SUBJECT: First Five-Year Review Report  
Piper Aircraft Superfund Site  
Vero Beach, Indian River County, Florida

**First Five-Year Review Report for  
PIPER AIRCRAFT NPL SITE  
The New Piper Aircraft, Inc.  
Vero Beach, Indian River County, Florida**

Thank you for your submittal of the First Five-Year Review Report (DRAFT). EPA and FDEP have reviewed the document and submit the following comments. The Five-Year Review process is intended, in part, to evaluate the protectiveness of the selected remedial action. According to the details in the report, EPA feels that modifications to the remedial action should be considered by Piper because the UVB wells do not appear to be operating properly and adjustments could be made in the location and monitoring of the monitoring wells to improve the systems efficiency. Please view this comment letter in two respects. First, comments on the report itself (listed mostly in Section 1.) should be addressed so the that the report can be finalized and approved by EPA. Second, comments concerning the potential modifications to the remedial action (Sections 2. through 5.) should be considered in any future work at the site. EPA requests to have a m

Figure 1. TCE Concentration Versus Time at MW-4S

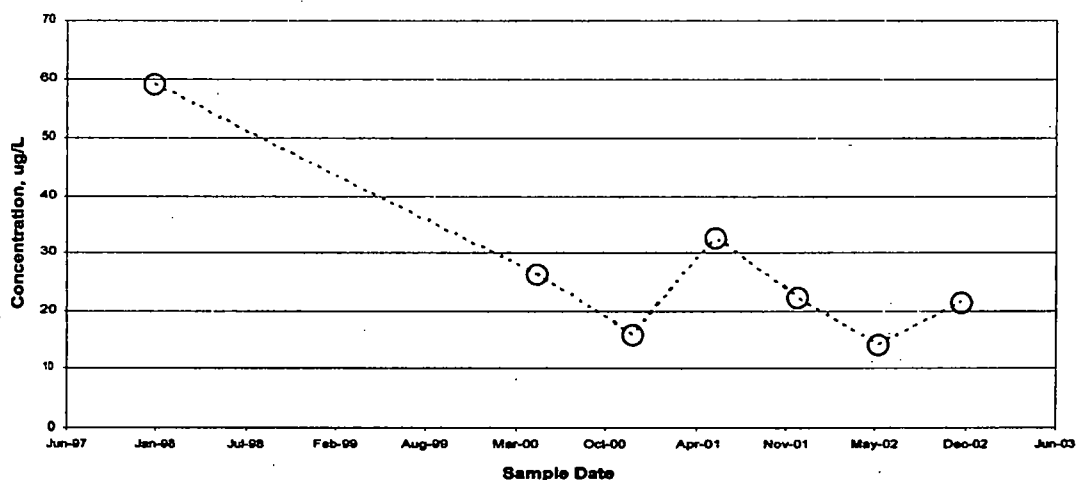
- 3.1 In the up-gradient area of contamination, UVB-1 never recovered significant concentrations of VOCs, as documented in the Five-Year Review Report, Table 1. This well was

eventually replaced with UVB-1A in 2001. The Five-Year Review Report indicates that while UVB-1A has a design capacity of approximately 50 gallons per minute, it has been operating at 15 gallons per minute. The Five-Year Review Report does not include any documentation of the estimated area of influence of UVB-1A or its predecessor, the UVB-1 well. Thus, while the concentrations of contaminants in samples from monitoring wells near UVB-1A show dramatic decreases following startup of that well, it is not clear the extent of the area of this apparently effective ground water remedial action. Based on data from some of the monitoring wells in this up-gradient part of the Site (MW-4S in particular; see Figure 1 below), there may not be much current effect of UVB-1A on part of the up-gradient contamination.

### 3.1 NewPiper Response :

***With the water-table averaging approximately 9 feet below land surface, and the screen setting of 12 to 21 feet below land surface, only three feet of available draw-down remains before the screen begins to dewater. A screen alternately wetted and exposed to the atmosphere encrusts very rapidly with a hard form of iron oxide whereas deeper constantly wetted screens at this site accumulate a softer red mud type which is easier to remove with air development. Fortunately, there has been no infestation with iron***

Figure 2. Vinyl Chloride Concentrations Versus Time at MW-17

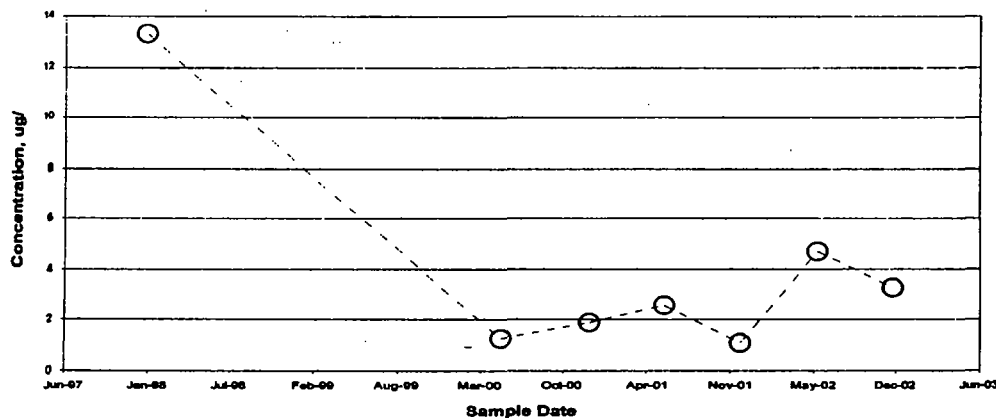
- 3.2 Mid-plume monitoring wells appear to be poorly placed to track the progress of the remedial action. MW-16 is best located to monitor the progress of the remedial action, but data from that well are too variable over the period of UVB well operation to make any reasonable judgement about changes in water quality in the mid-plume area. MW-17 is another mid-plume well and data from that well suggest that the remedial action is having little or no effect on the concentration of vinyl chloride in that part of the plume (Figure 2).

### 3.2 NewPiper Response :

*The MW-17 well area, some distance north of the interpreted axis of plume occurrence contains only low level VC in the intermediate depth range. The area will be included in modified remediation planning with regard to geoprobe tasking and possibly deeper*

Figure 3. MW-16 Concentration Trends

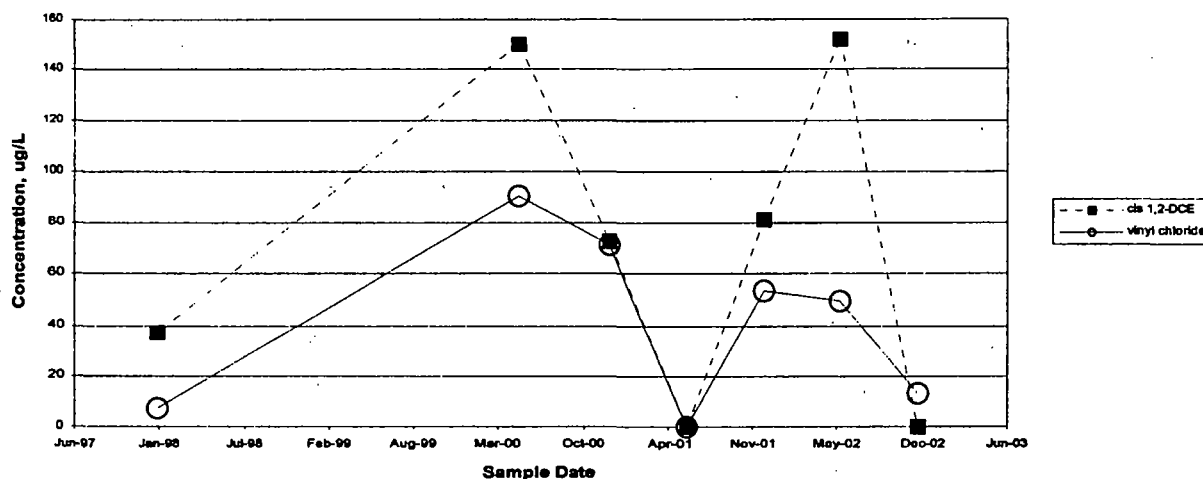
At MW-16, time-concentration data present an unclear picture of time concentration trends for vinyl chloride and cis 1,2-DCE. These are the two contaminants of concern that have been detected at that location in concentrations periodically exceeding their respective MCLs. **Figure 3** shows the MW-16 time-concentration data for cis 1,2-DCE and vinyl chloride. The pattern of highly variable concentrations suggests either different well sampling and purging procedures or slightly different flow patterns in the aquifer. Either condition may result in a sample representing either deeper, more contaminated ground water or shallower, less contaminated ground water (or ground water that is at times more representative of the plume centerline concentrations in this part of the plume).

There is clearly a need for alternate monitoring locations or monitoring strategies in the mid-plume area. Neither MW-17 nor MW-16 appear to be properly placed to track the core of the contaminant plume in this area. MW-16 may be located in an area of steep concentration gradients, where minor changes in either flow direction or well purging and sampling procedures results in highly variable concentration changes between different sample events.

Figure 4. MW-19 Concentration Trends

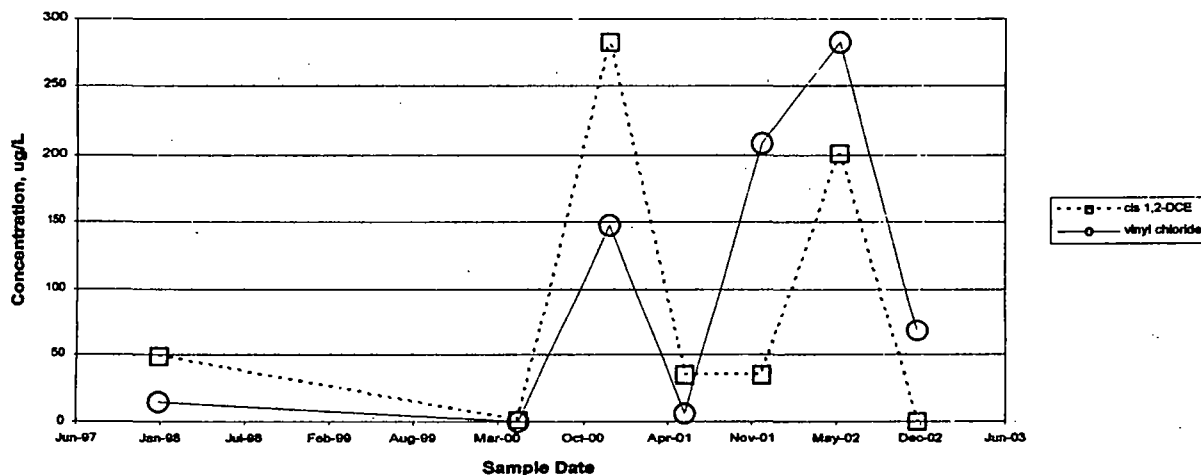
19, concentrations between different sample periods have been highly variable, similar to what is observed at MW-16 in the mid-plume area. **Figure 4** shows time-concentration data for MW-19. This figure shows that for MW-19, no statement can be made about the progress of the ground water remedial action in the part of the downgradient part of the plume monitored by that well.

#### 4.6 NewPiper Response :

**Figure 15 isopleths show a decrease in cis,-1,2 DCE from 1997 through 2002 in the area of MW-19. Isopleths are somewhat misleading in that they depict a smooth transition and connected occurrence of contamination. The residual contaminants probably occur in a three-dimensional random arrangement of small lenses and blobs, the placement of which is controlled by an interplay of hydrologic, geologic and phase relationship variables. Looking for a progressive downward trend in certain wells can be unproductive. The ups and downs in residual concentration shown by various wells despite a rigorous attempt to keep all sampling protocols identical are attributed to the sporadic and intermittent release of contaminants to the down gradient water flow occurring in a fairly anisotropic aquifer.**

Figure 5. Vero Beach Well #15 Concentration Trends

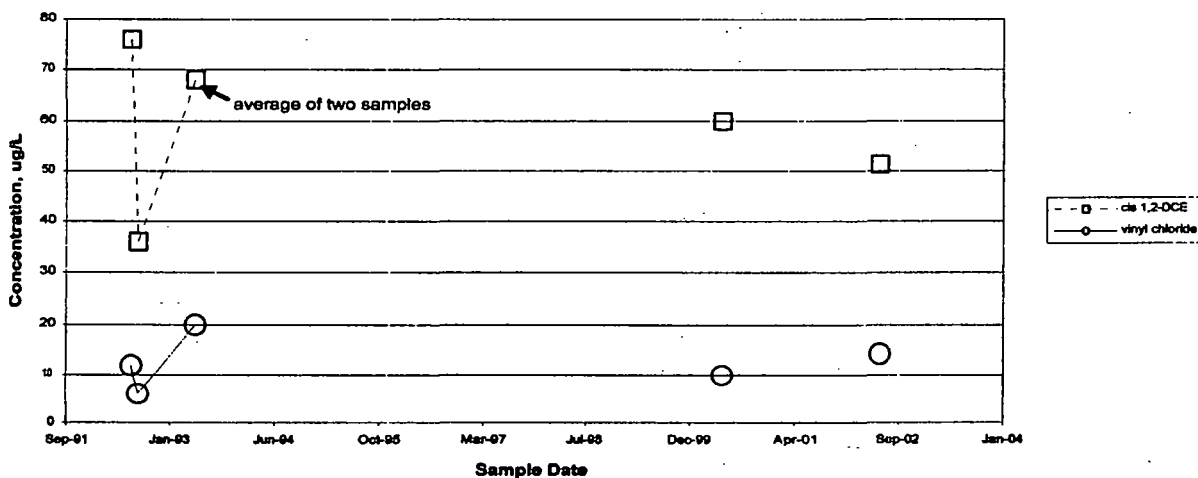
- 4.7 **City of Vero Beach Well (CW-15)** - Ground water quality data from the city well #15 are presented in Table 3 of the Five-Year Review Report. Only two samples from the well are included in the table (May 2000 and June 2002). The May 2000 sample contained 59.7 ug/L cis 1,2-DCE and 9.8 ug/L vinyl chloride. The June 2002 sample contained 51.2 ug/L cis 1,2-DCE and 14.3 ug/L vinyl chloride. This limited amount of data does

not indicate that the ground water remedial action at the Piper Site is effectively reducing concentrations at the water-supply well. For further comparison, data from city well #15 that were obtained during the RI are also summarized in EPA's 1993 Record of Decision. These data indicated that in the 1992 to 1993 time period, cis 1,2-DCE was present at concentrations of between 36 and 76 ug/L, while vinyl chloride was present at concentrations in the range of 5.9 to 20 ug/L. **Figure 5** shows time-concentration data from Vero Beach well #15.

The presence of continuing concentrations of vinyl chloride above its stated MCL and at concentrations comparable to those observed almost a decade earlier is an indication that the remedial action needs to be modified to better control movement of contaminated ground water beyond the more downgradient area of ground water remediation at the Site (the UVB-2 area). This comment was also made by FDEP.

*The zones of UVB capture are small compared to the zone of capture for CVB #15 and comprise a minimal influence on residual contamination levels.*

*Agreed; NewPiper has been investigating alternative remedial technology to augment existing remedial methodology.*
